ADDENDUM NO. 1
TO
PROCUREMENT AND CONTRACTING REQUIREMENTS
FOR
NineStar CR200 Sewer – Division I
FOR
NINESTAR CONNECT
Issue Date: October 25th, 2023

The following, as additions to and modifications in the Bidding Requirements and Contract Documents, will be included in, and become a part of the **NineStar CR200 Sewer – Division I**. This Addendum forms a part of the Contract Documents. Bidders are, therefore, instructed to take the following into account in rendering any Bid for this work. Acknowledge receipt of this Addendum in the space provided on the Bid Form.

T001

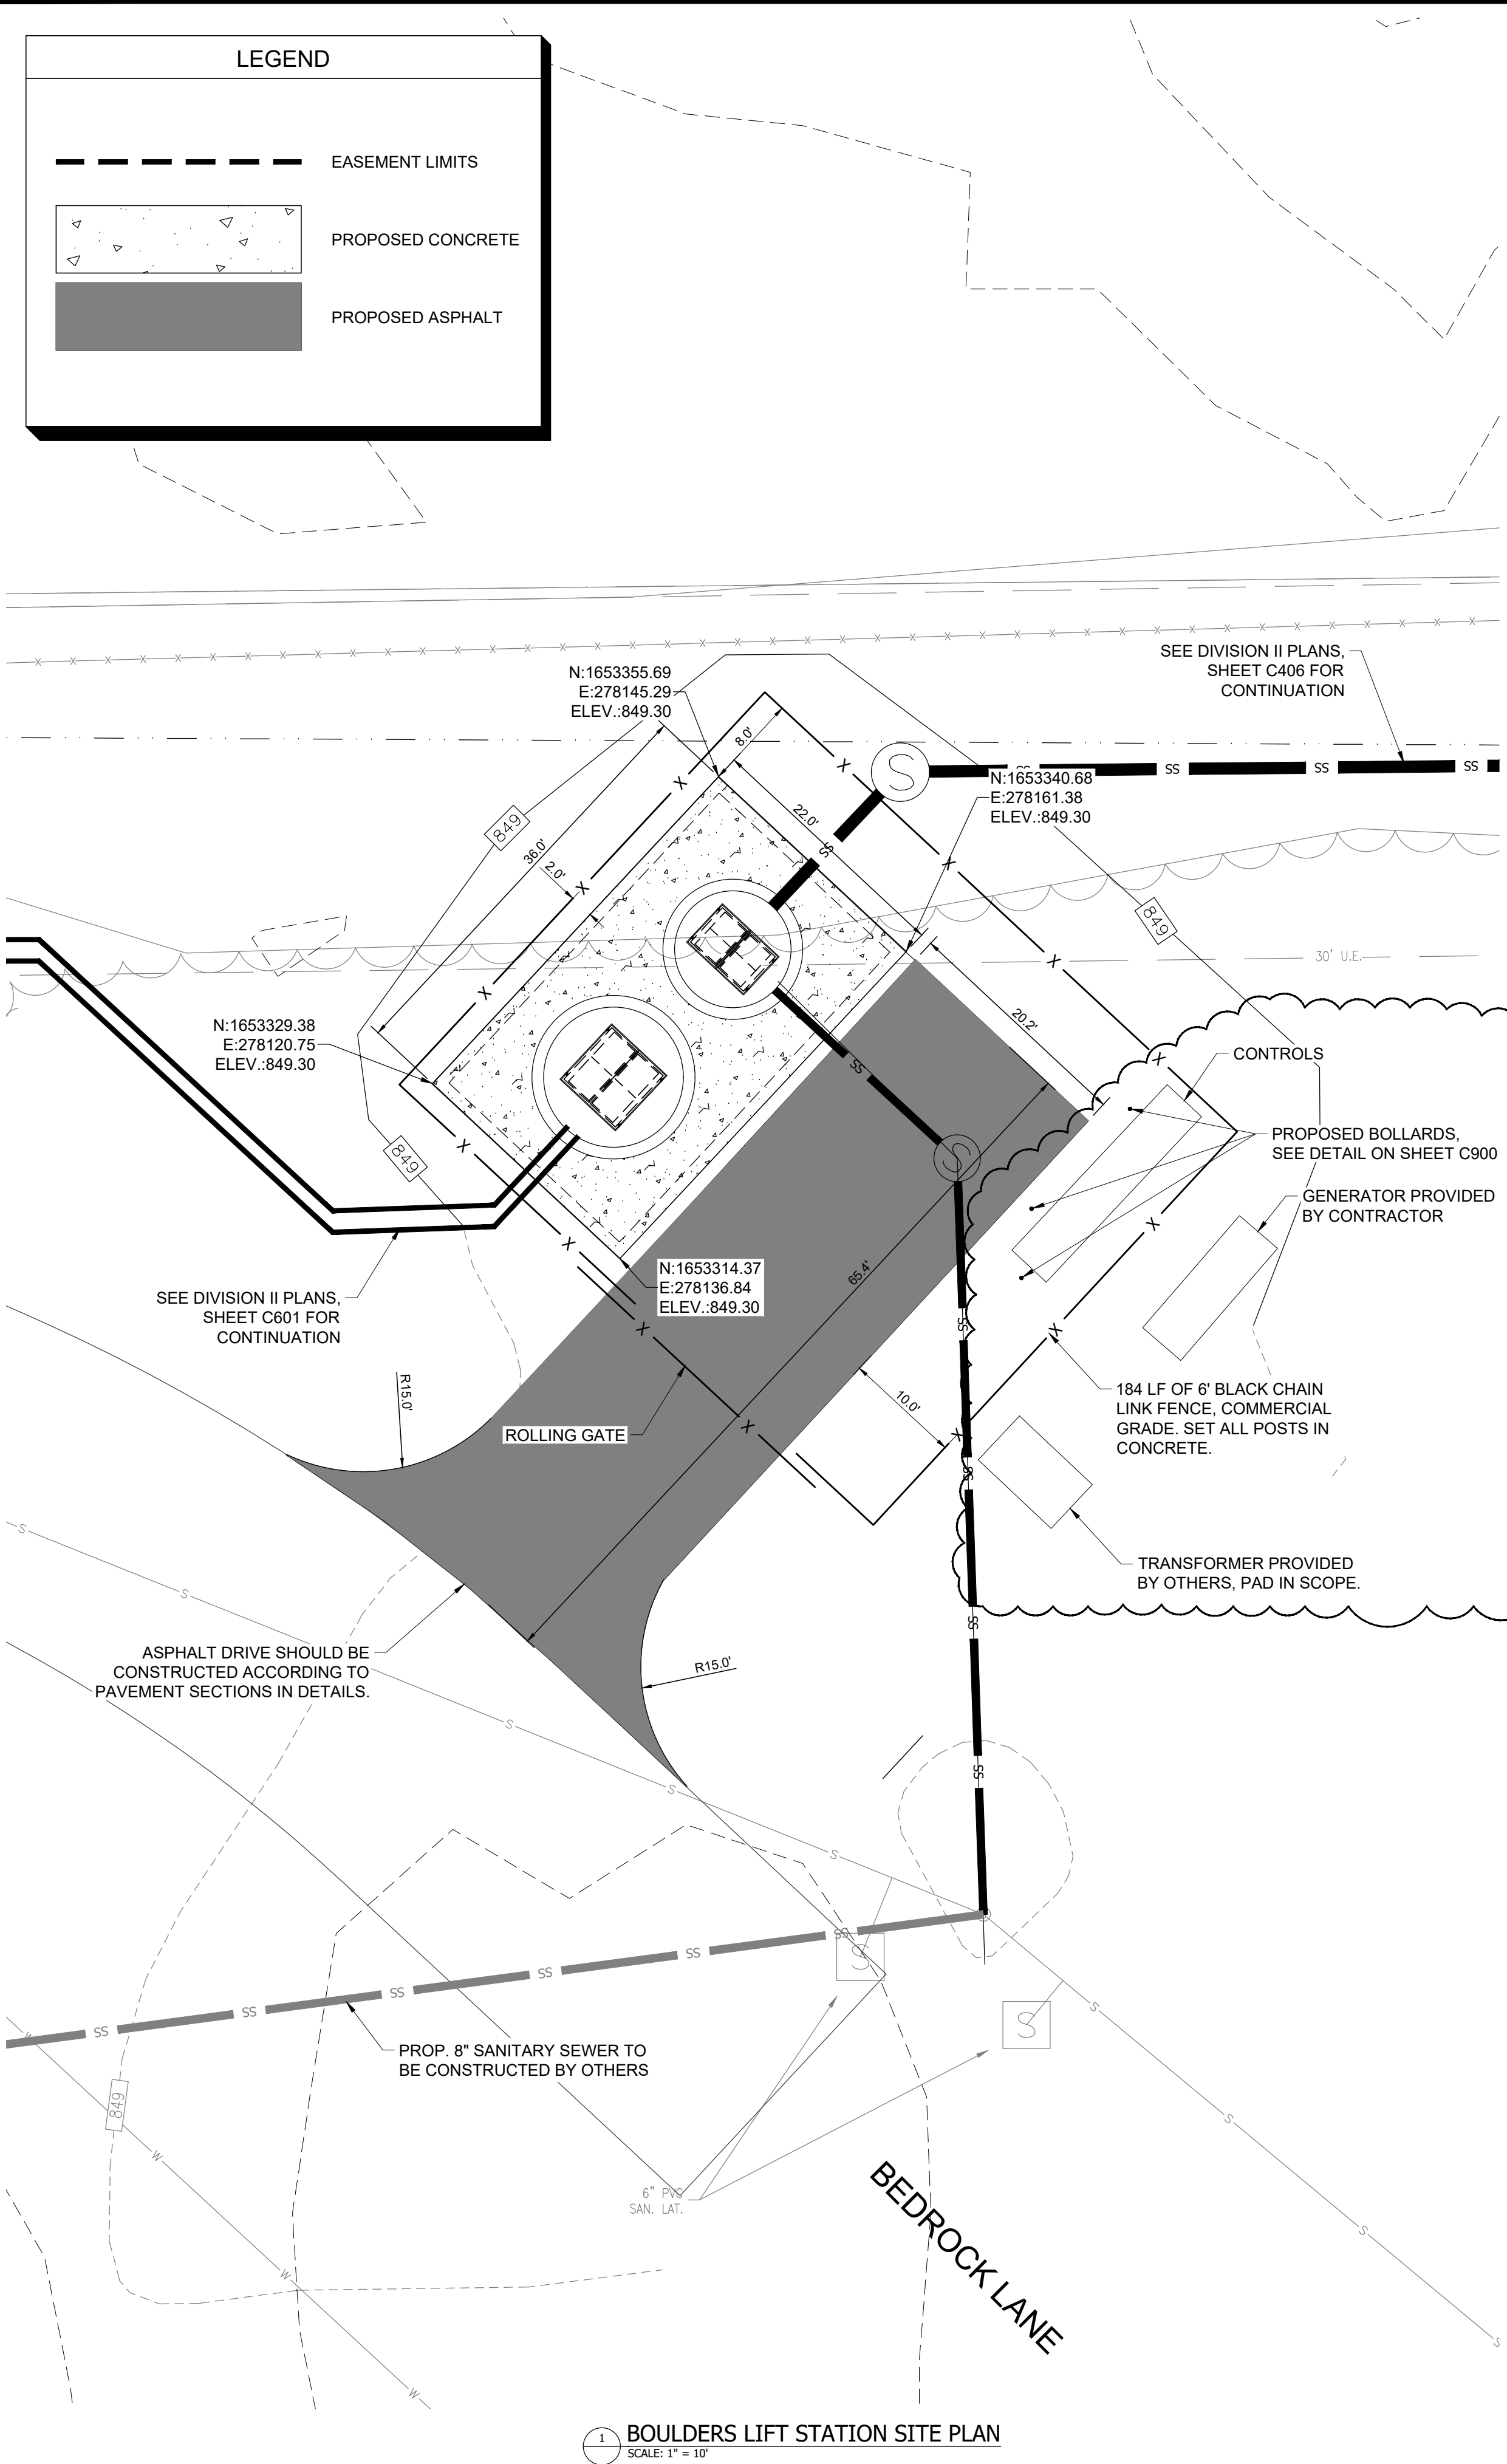
1. Revised Plan Sheets – **Attachment No. 2** of this addendum:
 - a. Sheet T001 - Title Sheet (Updated Index and fixed typographical error in project overview map.)

1 BOULDERS LIFT STATION SITE PLAN
SCALE: 1"=10'

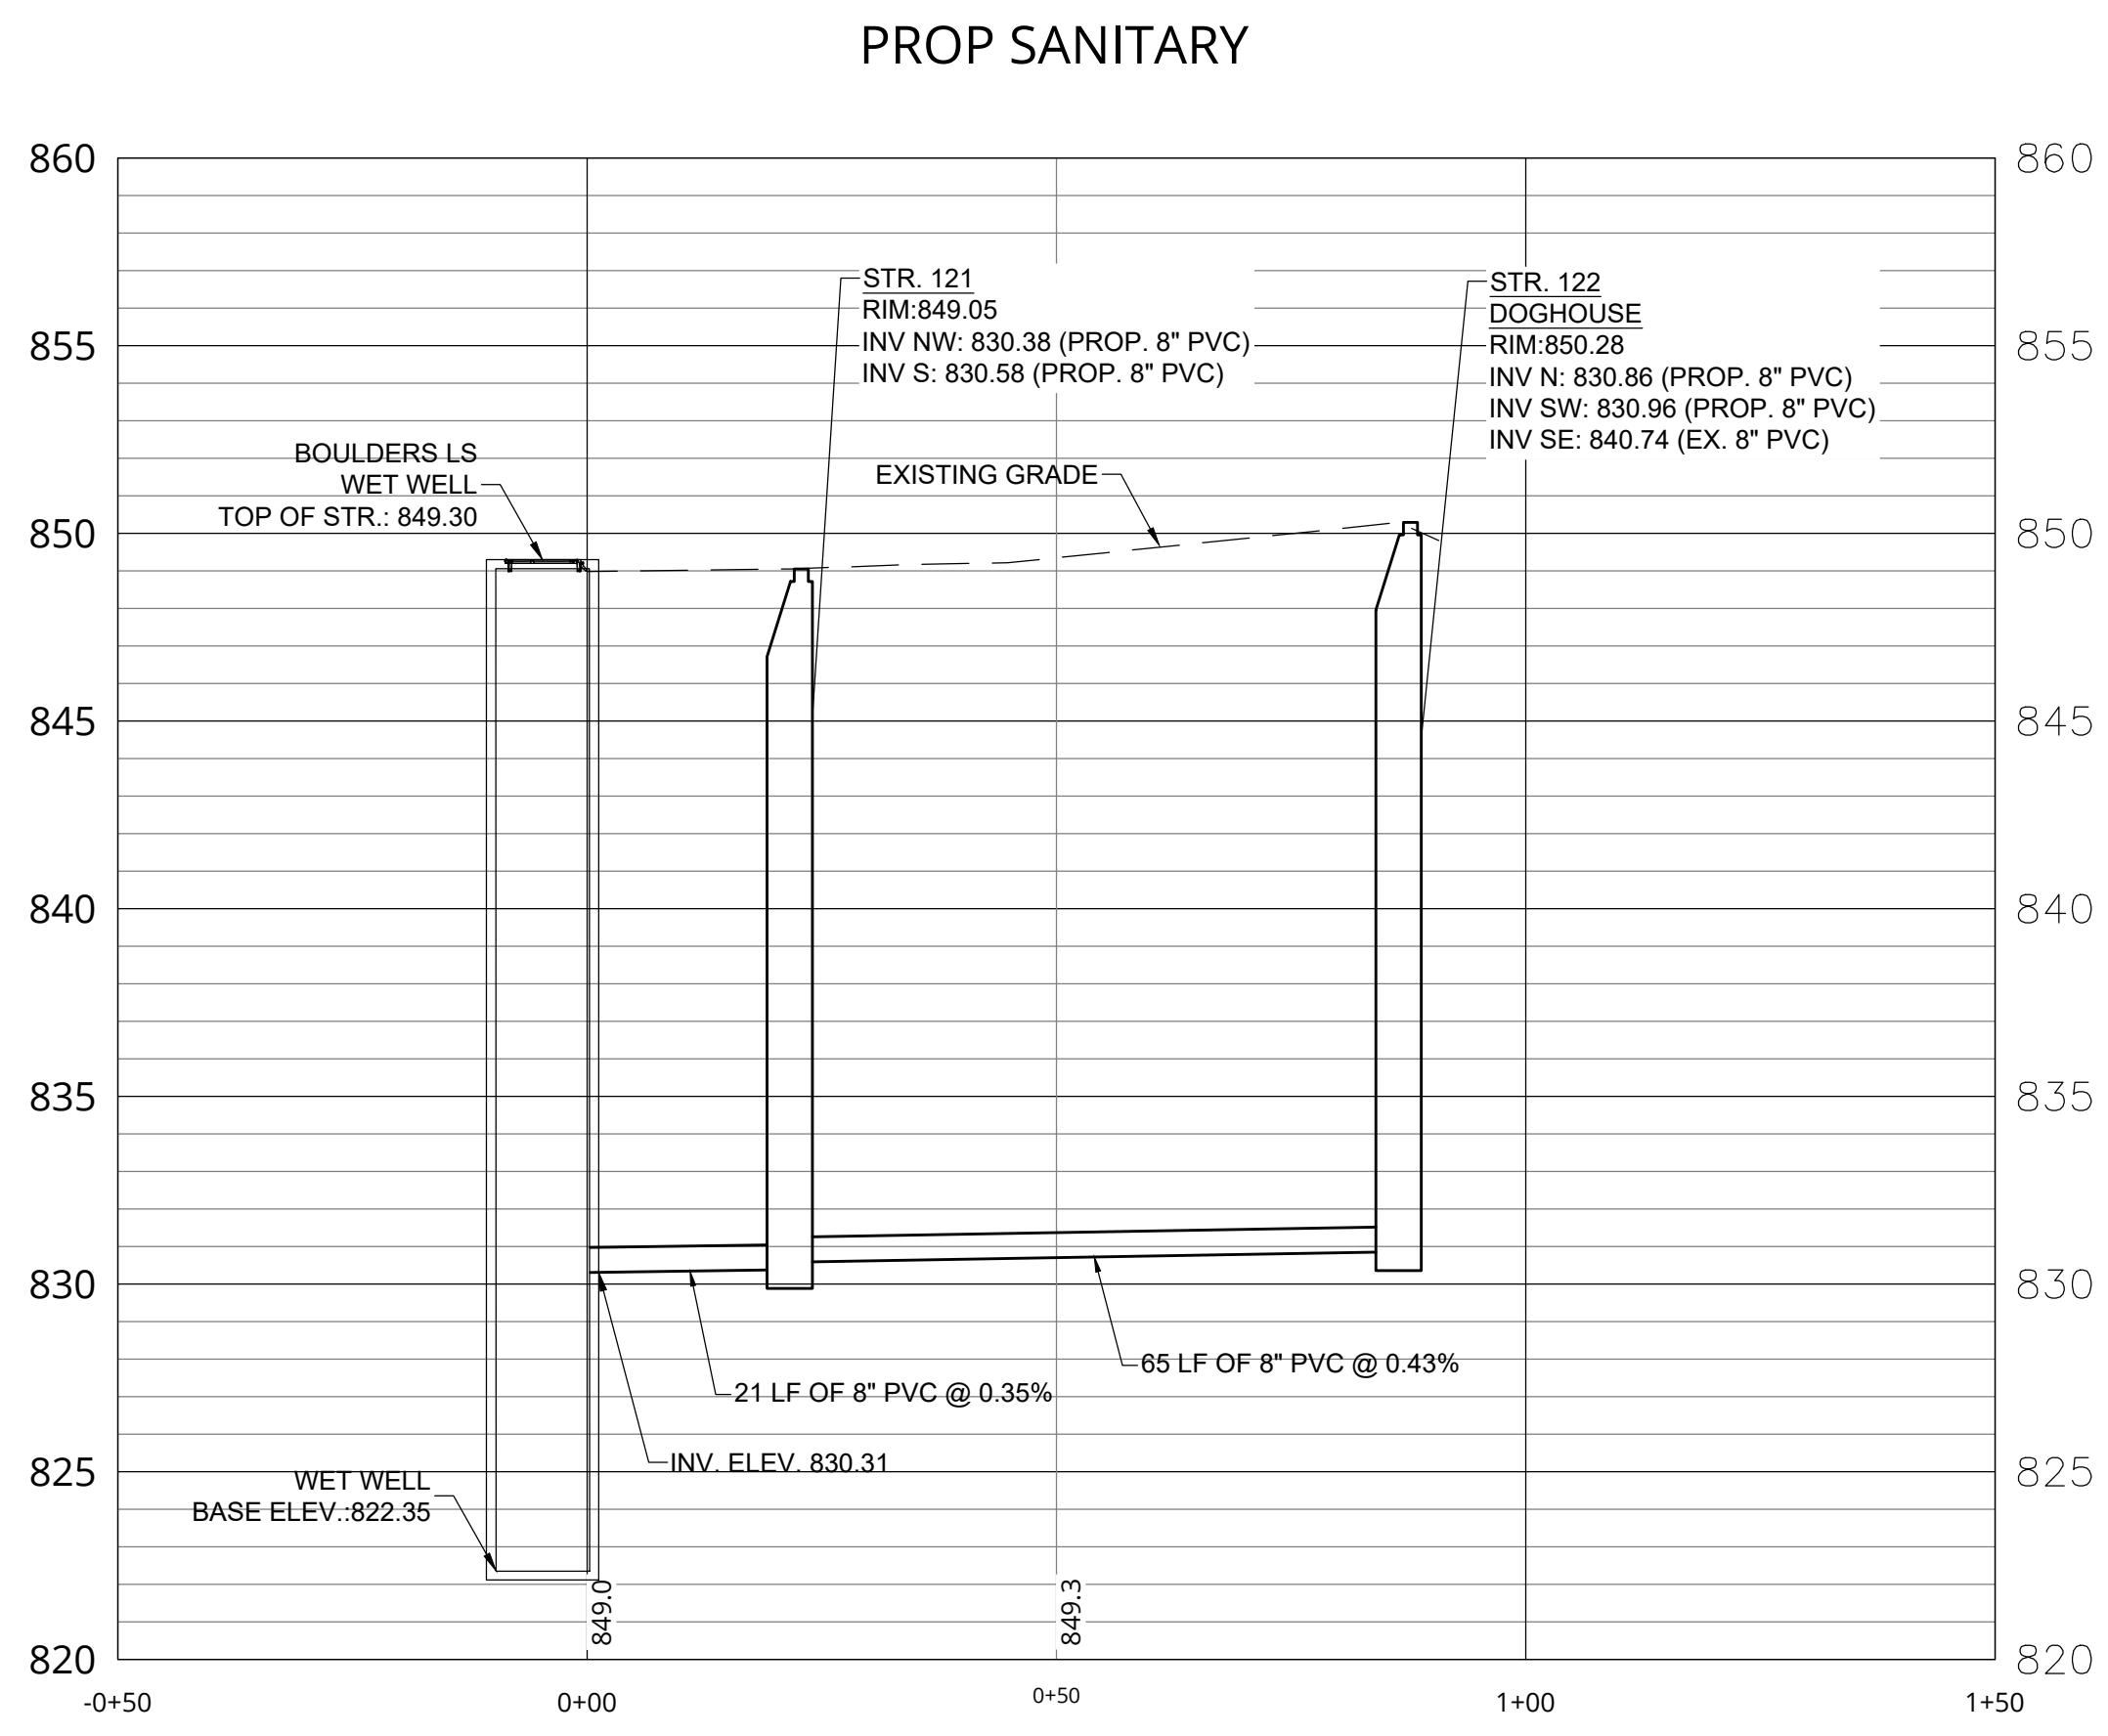
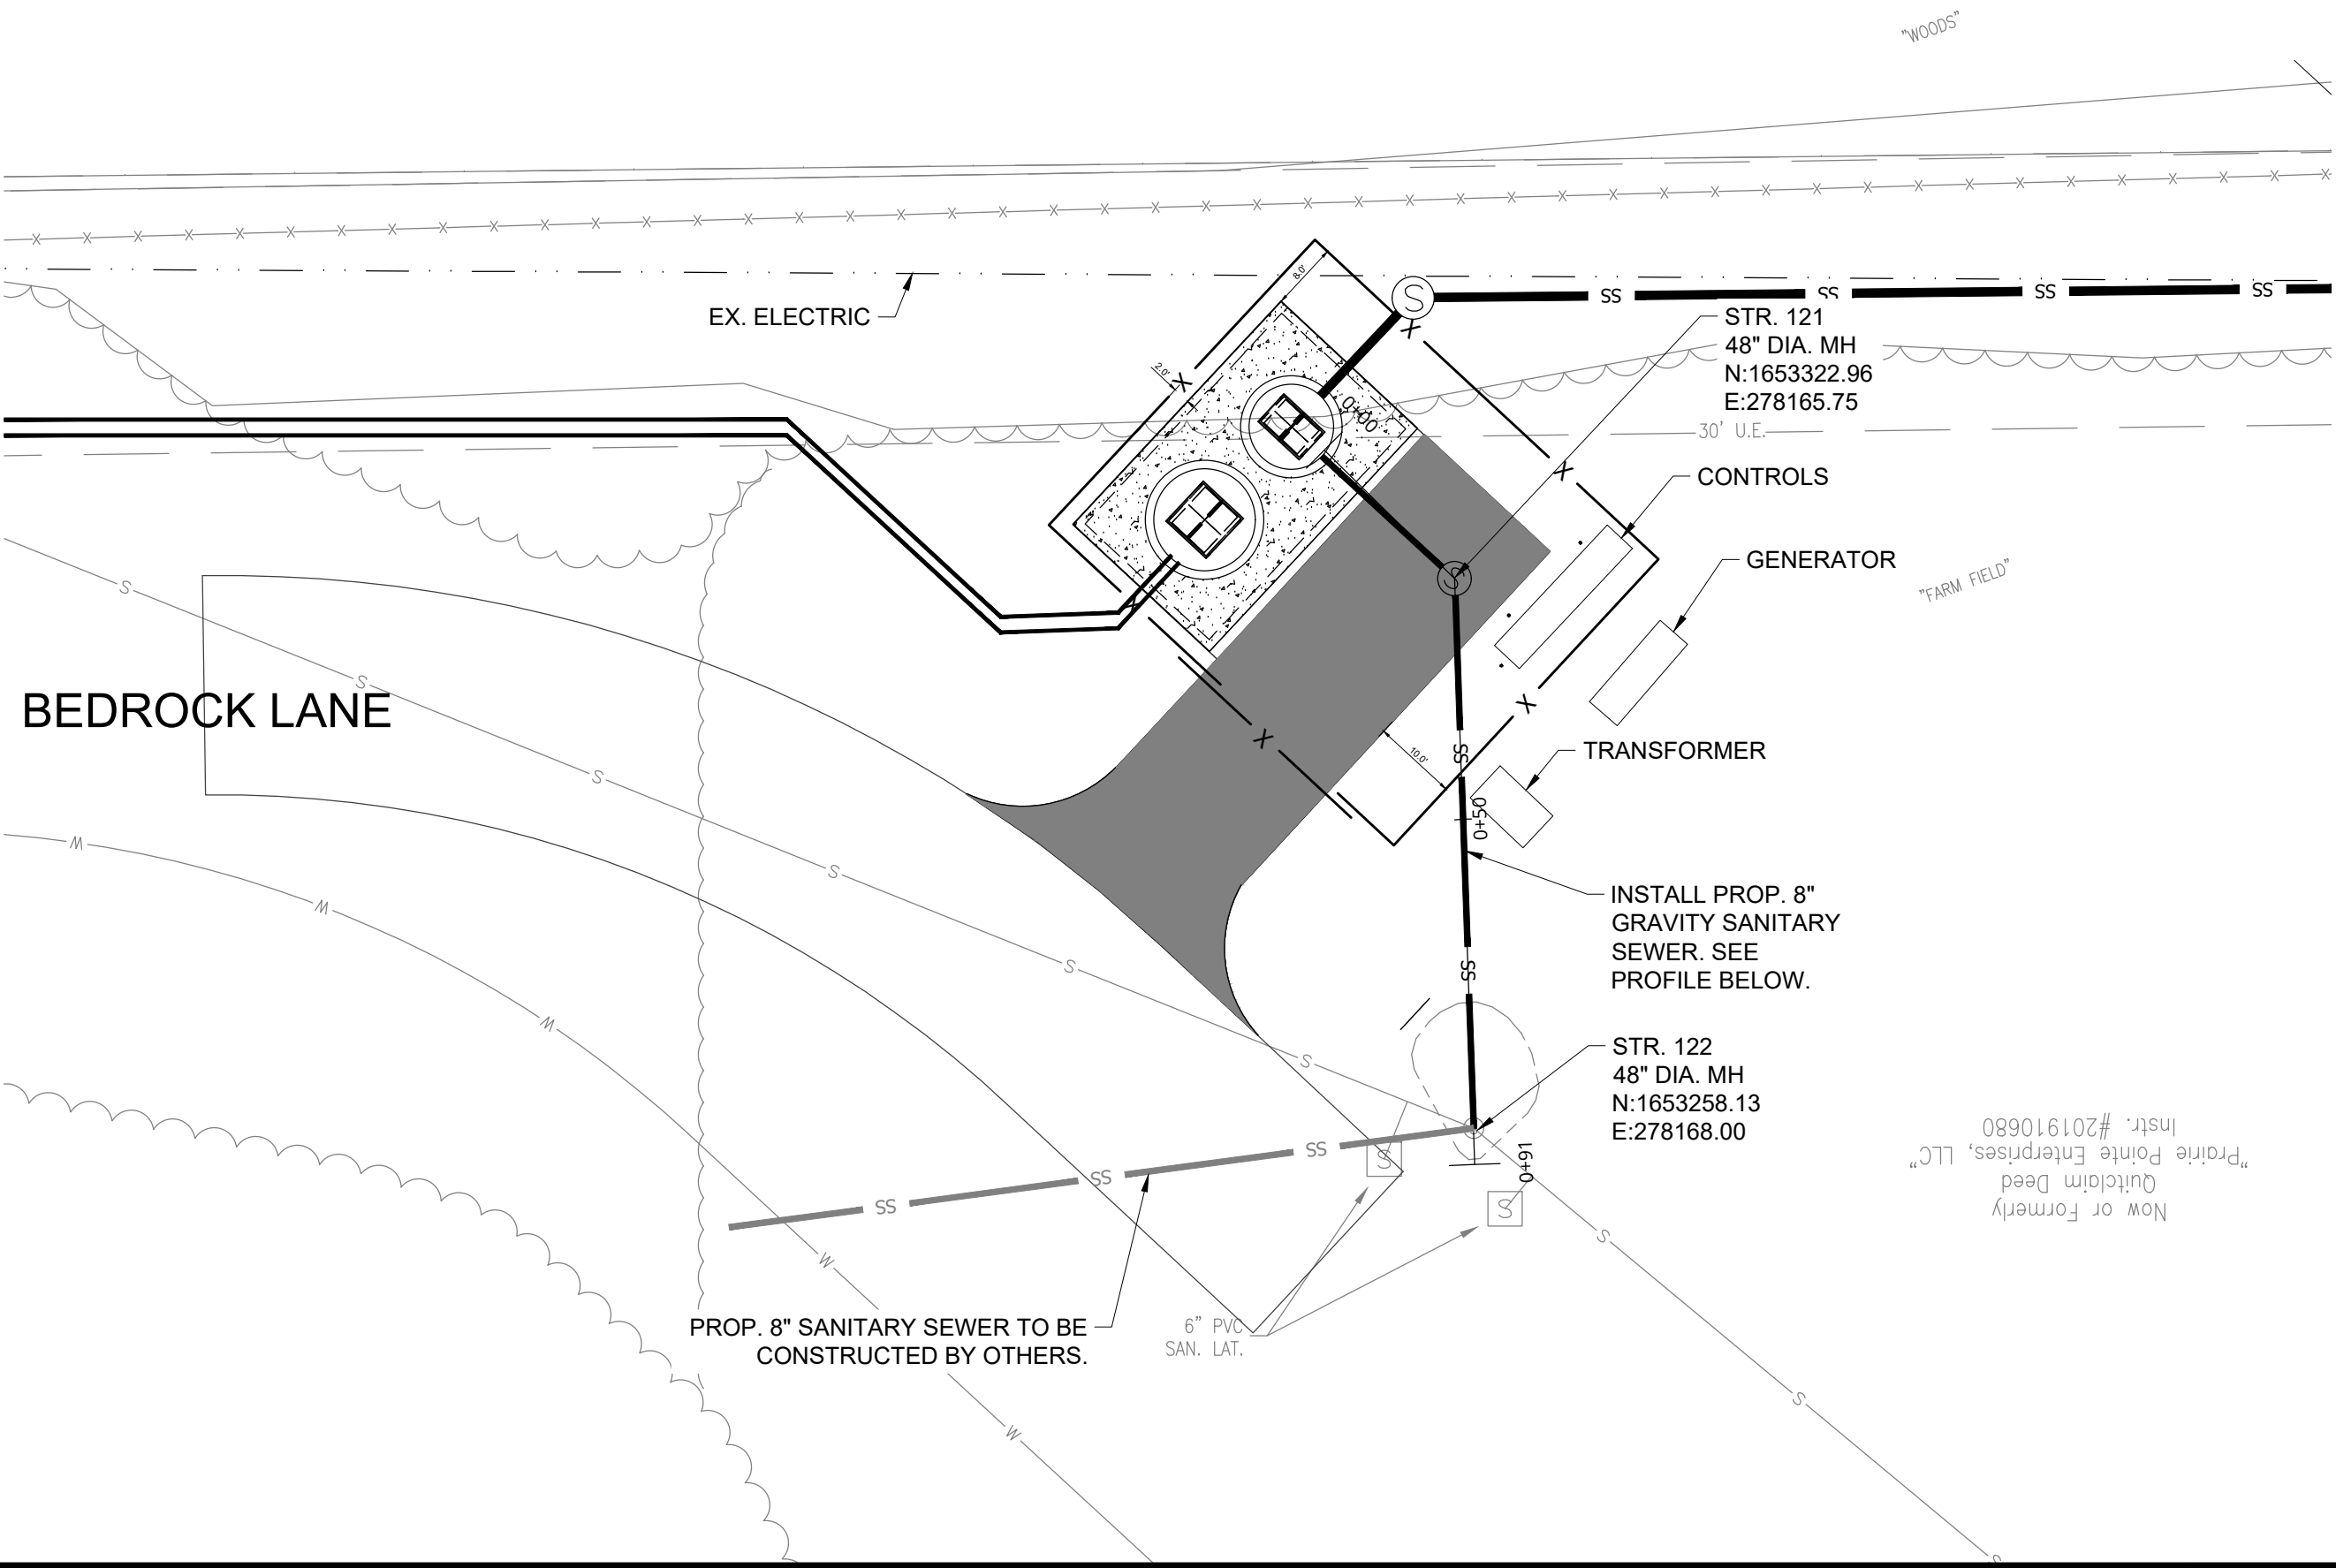
- b. Sheet C601 – Boulders Lift Station Site Plan (Updated site to include protective bollards as well as appropriate sized areas for controls, new generator, and transformer.)
